OFFICE OF THE
TOWN PLANNER

Re: TRC Variance Recommendations (Consent Agenda Items)

Whispering Oaks Subdivision – Master Plan
Staff Report for the March 22, 2023 Planning Board Meeting

Project Name:	Whispering Oaks Subdivision	TRC Meeting: 3/14/2023
Application Type:	Major Subdivision	
Review Phase:	Master Plan	
Project Address:	100 & 110 Jenckes Hill Road	
Plat and Lot:	AP 43 Lots 15 & 91	
Zone:	RA-40	
Land Area:	13.29 acres	
Future Land Use:	Med-Low (1-2 acre)	
Owner/Applicant:	Oakley Holdings, LLC & Philip A. Oakley & Lisa M. Misiaszek

SITE PLAN

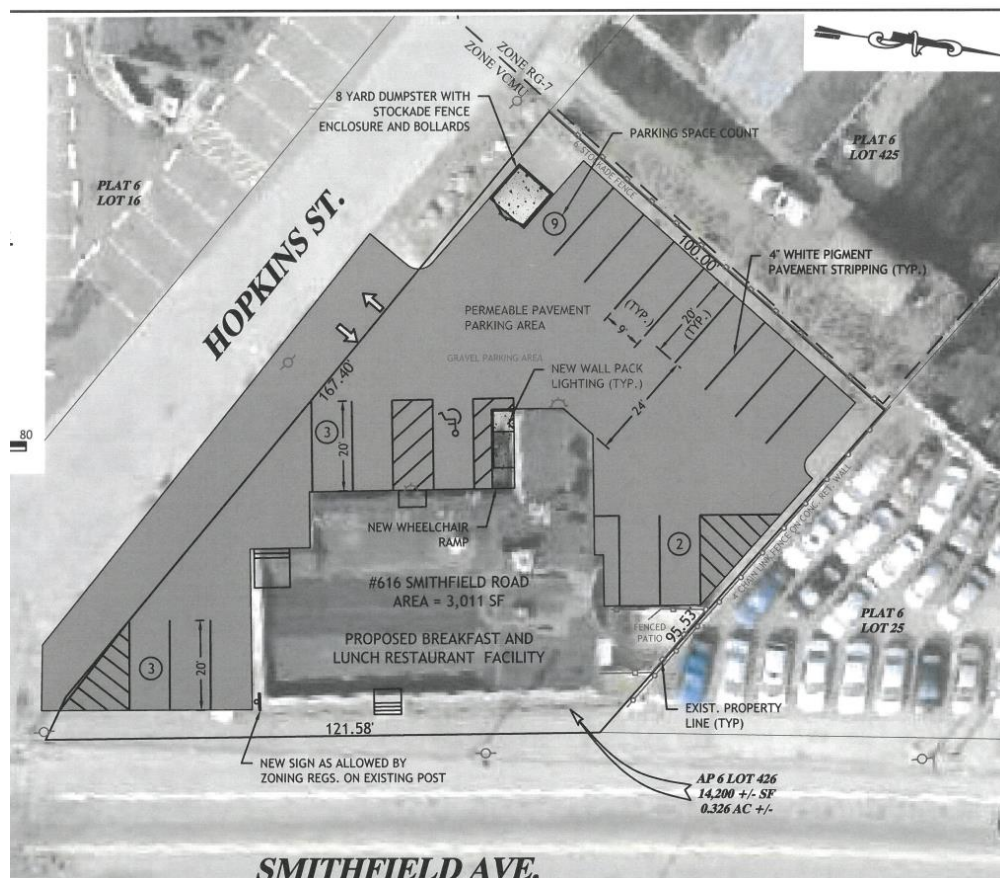
Application to allow 17 off-street parking spaces when 31 are required for their proposed restaurant to relocate to the existing building.

The subject property is 14,375 SF lot with a 3,011 SF building. The existing parking area is not paved or striped, and is limited based on the shape of the lot in relation to the footprint of the existing building. The applicant proposed pervious pavement and striping of 17 spaces, one of which would be ADA accessible (there are currently no ADA spaces). There is an existing 6' stockade fence between the parking area and the residential abutter to the west. The TRC noted, however, that the fence may not be sufficient to buffer the abutter from the proposed dumpster and asked the applicant to move the dumpster to the northern property line abutting the used car lot at AP 6 Lot 25. The TRC was concerned with the lack of available parking and also the lack of available on-street parking due to the open curbs and parking arrangement for the subject use and Frank's Family Restaurant across the street. Despite the concern, the TRC

recognizes the limitations of the existing site conditions and acknowledges the applicant's efforts to make the best use of the limited space.

Considering the existing conditions and previous uses of the site the TRC finds that the relief requested would not alter the general character of the surrounding area nor impair the intent or purpose of the Zoning Code nor Comprehensive Plan. The TRC voted (6-0) to recommend that the Planning Board make a **positive recommendation** on this application to the Zoning Board of Review with the conditions that the dumpster be relocated to abut AP 6 Lot 25.

Drainage & Utility Plan NORTH Snippet (Sheet 6 of 6)

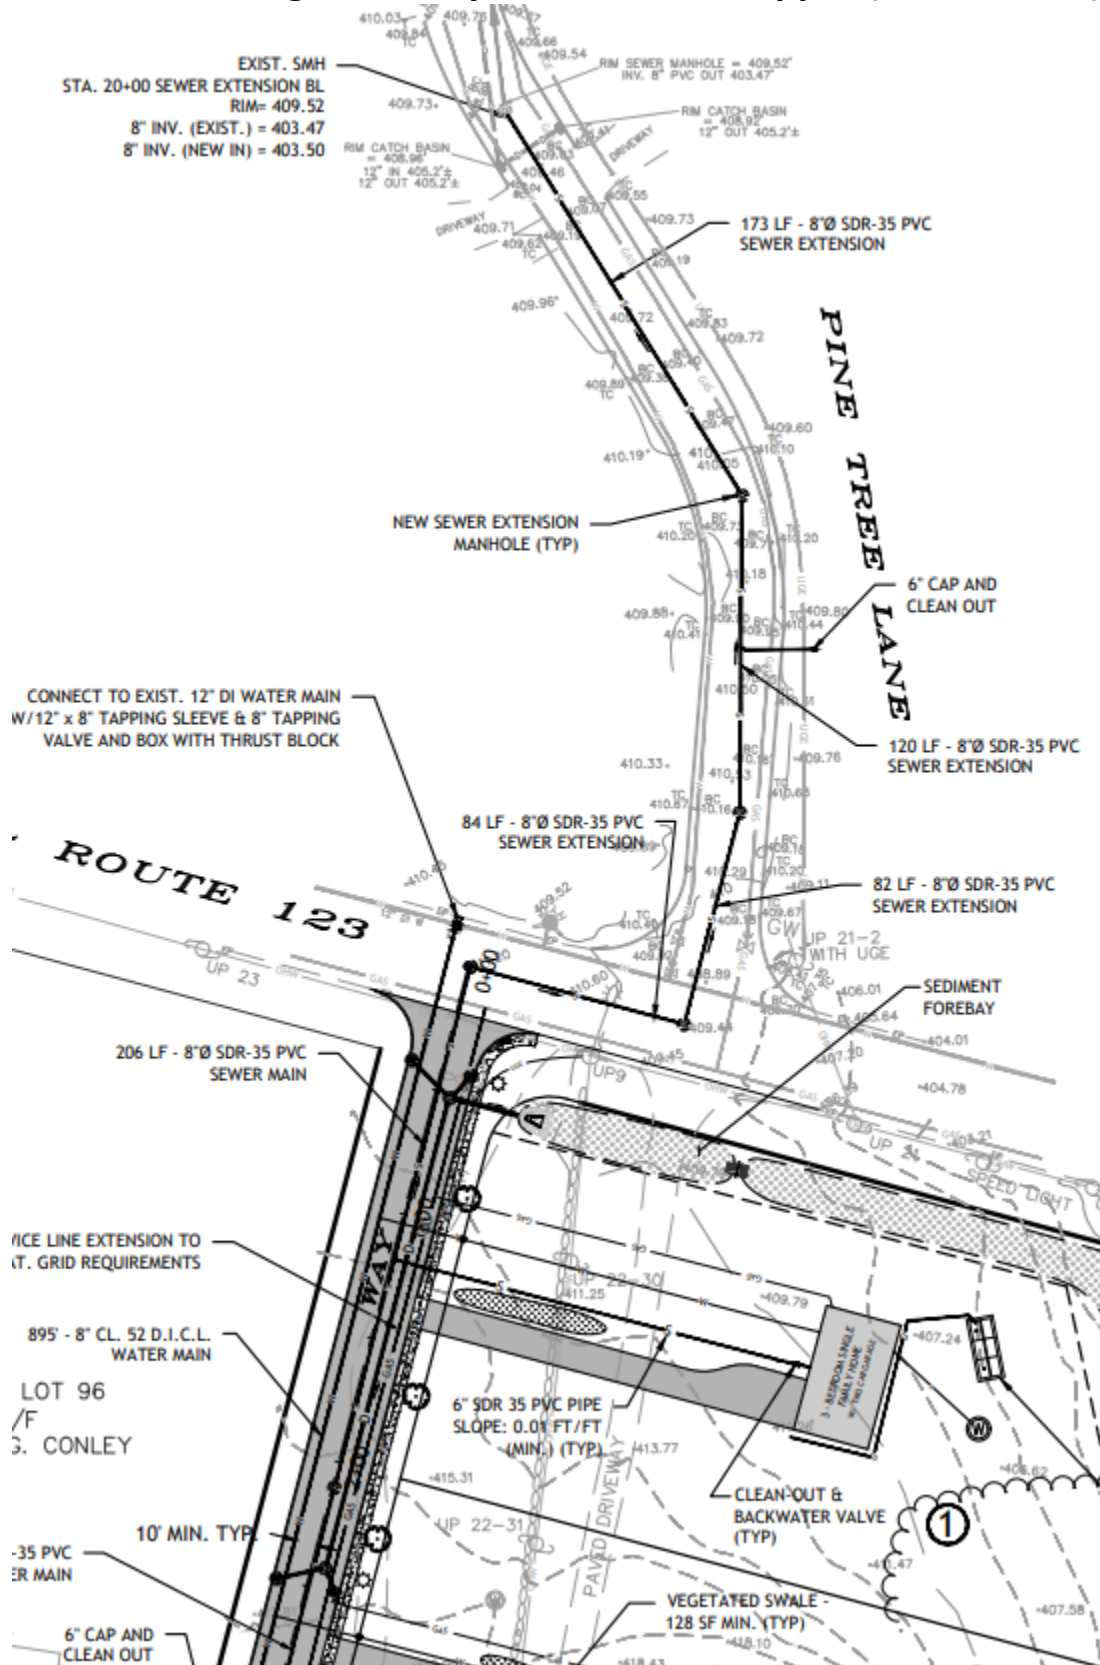
The applicant proposed public water and sewer for all nine (9) lots. The gravity sewer main will have to be extended from Pine Tree Lane. Stub outs to homes on Pine Tree Lane and AP 43 Lot 96 are being provided. At the point where the gravity system is infeasible and a low pressure force main (LPFM) is required, the LPFM must be located outside of the public right-of-way beginning on proposed Lot 3. A 10' easement to be provided to the HOA is shown on the plans, potentially requiring a waiver from the 20' width requirement. A sewer availability letter has been issued. There is a note on sheet 5 of 6 of the plans that "all lots with sewer grinder pump stations shall have emergency generators on-site. The generators should be sized at the minimum to power the sewer grinder pump station and the water well if provided."

1. The LPFM system shall be privately owned and maintained by a homeowners association.
2. Generators shall be required on each lot with a grinder pump system to ensure power during power outages.
